Propeller Nut Torque Change For Propeller Applications Using Prop Hub Bushing 23-856163Q 1

All propeller applications including surface piercing using hub bushing.

19134

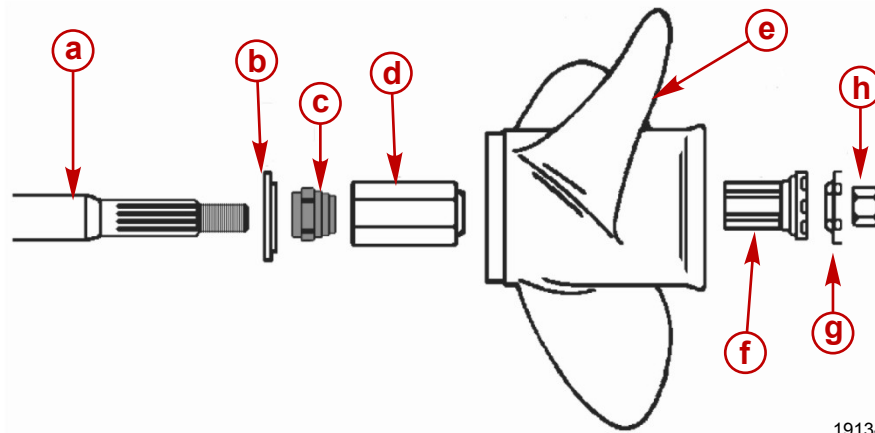
The potential exists where the present torque of 74.5 Nm (55 lb.ft.) on the propeller nut is not sufficient to allow the thrust washer (b) to pilot into the propeller (e). This applies to all applications including surface piercing propeller application.

An increase from 74.5 Nm (55 lb.ft.) to 135.5 Nm (100 lb.ft.) torque on the propeller nut was established to ensure the correct relationship of the propeller hub components when using the hub bushing propeller applications. The installation instructions for the Flo-Torq Drive Hub Propellers (90-832825 004) will be revised to reflect this new torque requirement.
